September 28, 1988
3F2988-20

Subject: Crystal River Unit 3
Docket No. 50-302
Operating License No. DPR-72
Emergency Feedwater

Responses to Emergency Feedwater
Questions of August 30, 1988

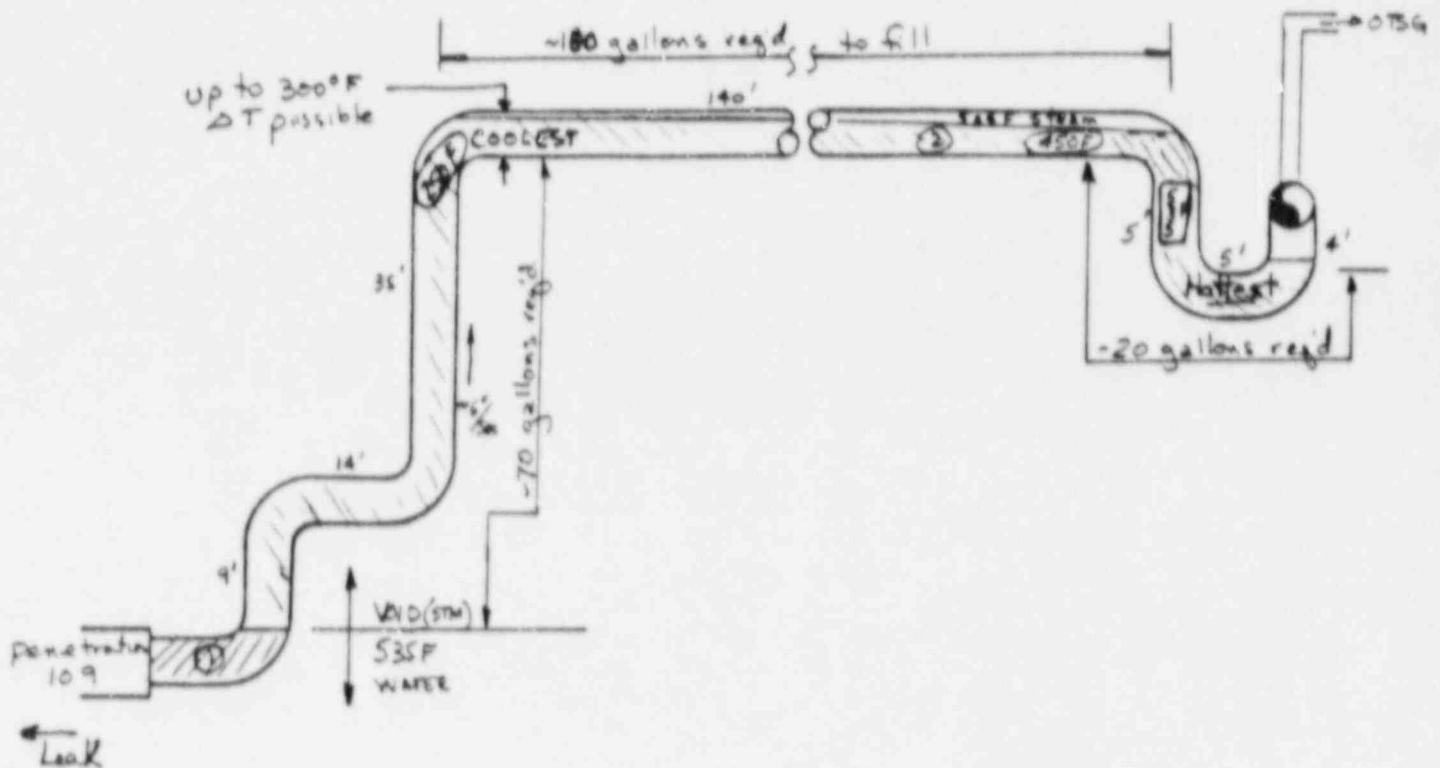
Thermal stratification in piping systems is known to result from low flow conditions. Thermal stratification can cause fatigue damage and large bending stresses. You should address the possibility that thermal stratification existed in the piping system as a result of the backleakage and line cooling, and address any damage to the piping that may have resulted.

Figure 2 depicts the anticipated thermal phases of the piping near the steam generator due to the 0.2 -0.7 gpm bonnet leak from EFV-18. Due to the upward thermal growth of the steam generator at temperature, the horizontal runs contain gentle downward slopes which could create localized traps for steam and water. Because of this geometry, as the water and piping heat up, counterflow conditions could permit cool water to flow under hotter, steam blanketed water which could result in thermal stratification for extremely short durations (figure 2).

- A. Steady state - no leakage, solid water system up to near ring header. Ring header and raisers (6) are full of steam.
- B. Leak causes water level to drop since leak rate is faster than condensing steam rate. Steam bubbles eventually reach vertical section and condense while heating vertical run. Some stratification exists in lower horizontal run but spring can support system permits pipe movement until the water heats to saturation.

- C. A steam pocket exists at 535 degrees F until it gives up its heat of vaporization to piping and nearby cool water. The steam supply is cut off until the pressure lowers.

- D. Condensation of bubble in "C" permits water to push from generator side up into horizontal run where pocket was. This, in turn permits hot water to return to lower section as pressures equalize with result looking like "C", but a larger pocket. Iterations continue between "C" & "D".

- E. Probable worst case stratification in the system induced by EFV-18 leak. Maximum delta T is expected at point (1) with somewhat lower delta T at point (2) due to heated water, and little or no delta T at point (3).

The remaining 138' of piping is horizontal and the next steam pocket size will run the entire piping length creating a large steam/water interface. This will result in faster condensation, hence faster water heating and somewhat lower delta T's.

50 GPM FILL SEQUENCE

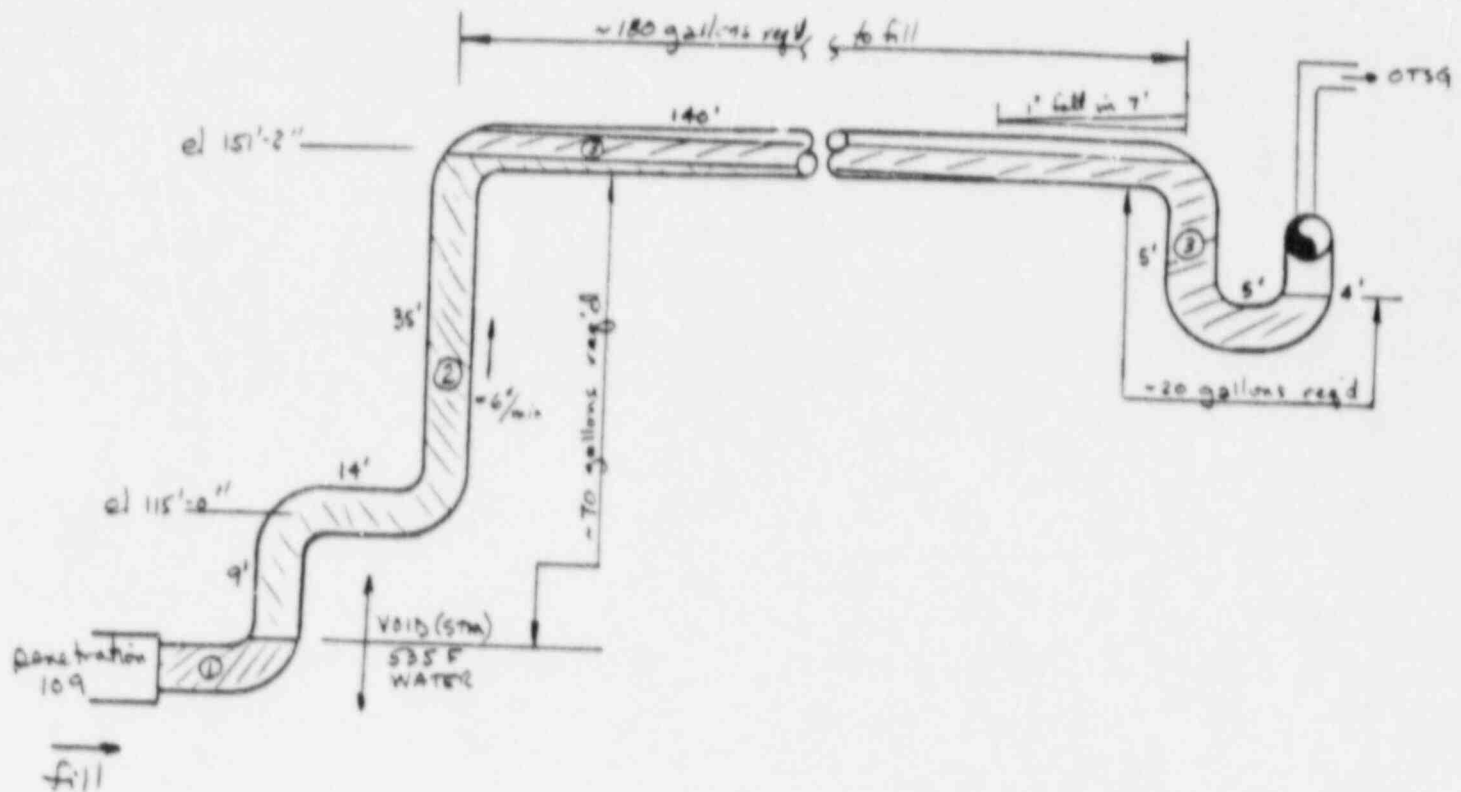
Figures 3 and 4 represent two flow rates that were used at CR-3 for cooling the line. A preliminary analysis performed by Babcock & Wilcox indicates back leakage greater than 0.09 gpm will eventually void the piping of water from the steam generator to the reactor building penetration. Based on local temperature readings of approximately 480°F outside the Reactor Building and the observed higher leak rates, it is believed the voided condition existed when the cooling operations were initiated. Figure 3 represents the 50 gpm (for 5 minutes) cooling approach used seven times during 1988. Figure 4 represents the virtually continuous 0.5-1.0 gpm line filling and cooling approach induced by the current temporary injection system.

In both fill cases, the first 100 gallons of water introduced are relatively hot. Additional heat is absorbed by this water from the vertical pipe wall as it ascends inside the building (see figure 1). During the 50 gpm fill, it will take the entire 250 gallons to fill the piping with the water never reaching the steam generator shell. A subsequent temperature profile could result in a stratified condition at the penetration end of the long horizontal run of the "B" steam generator which will quickly abate as the water obtains heat.

1. After sufficient time to void the line due to the leak, the piping run inside containment is virtually voided.
2. A 250 gallon injection at 50 gpm will not fill the line entirely. The 1st 100 gallons introduced to the horizontal run are hot and should fill the pipe halfway. The next 80 gallons would be cooler and the resultant thermal gradient in the pipe run would probably be on the order of 250 F to 450 F as shown above. This is very similar to the later phases of the leak described in Figure 2, since the leak continues.

CR3 AFW CONDENSATION WATER HAMMER EVAL.
 CR3.5510.720.2 REV.0, J. CAJIGAS, 8-29-88
 AFW MIN. FLOW FOR ON-SET OF COND. WH

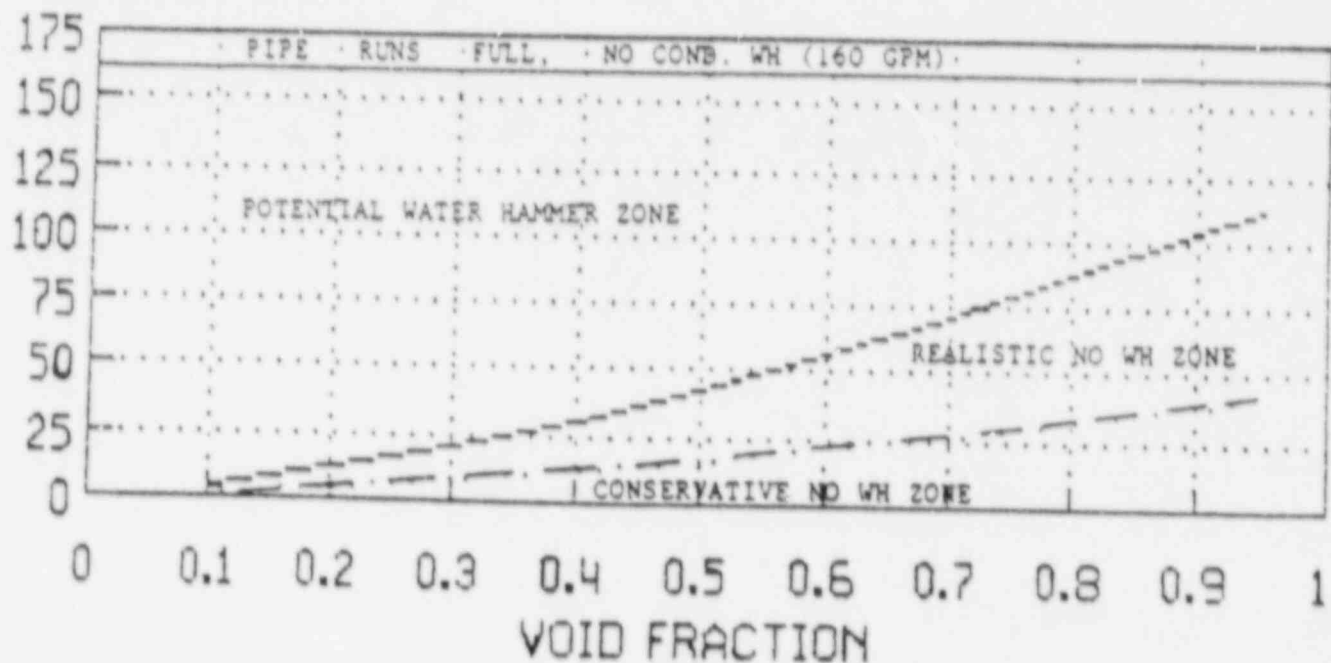
In response to CAL item number 4, you identified a number of reasons why you believe that the potential for water hammer was considered unaffected by the backleakage. These reasons have been reviewed, and the staff feels that FPC should provide more substantially supported arguments to resolve the question of whether a water hammer could or did occur.

2. 50 gpm fill - An Operating Procedure (OP-450) describes this technique to prevent steam binding in the EF pumps. This procedure was employed seven times to cool the line and seat FWV-43. There is a potential for two phase waterhammer (see figure 5) when the line is greater than 45% full of water.

3. 125 gpm fill - this is the flow produced when EFIC is actuated and when the level in the steam generator is above the desired water level set point. Two phase waterhammer is possible, per figure 5, at all fill depths.

4. The other extreme is the low flow injection system currently being employed to maintain inventory in the line. This is not considered to be a waterhammer concern because the flow rates are below 1 gpm (see figure 5).

Conditions 1 and 3 did not occur at CR-3 during the high temperature condition but are being evaluated because the possibility of this type of flow introduction did exist. Condition 2 did occur seven times. Two phase type waterhammer can only happen when filling horizontal lines and downward flowing vertical lines where steam can be trapped between water slugs. This type of geometry exists in the long horizontal run that terminates in the downturn to the steam generator trap (see figure 1). Gilbert Commonwealth, Inc. analyses shows that only flow rates below 160 gpm could exhibit some degree of two phase waterhammer in a six inch line with the conditions described in Figure 5. Flows in excess of 160 gpm simulate full piping bounded by the single phase fill conditions.

Preliminary assessment indicates waterhammer did not occur during the 50 gpm cooling cycles, however an inspection will be performed in the vicinity where the waterhammer would have most likely been initiated. Inspections will be performed on the horizontal run near the "B" steam generator and will include EFH-25A which is the only restraint utilizing concrete anchors and the most susceptible to damage. Formal analytical data for cases 1, 2 & 3 are due from Gilbert Commonwealth, Inc. on October 10, 1988.
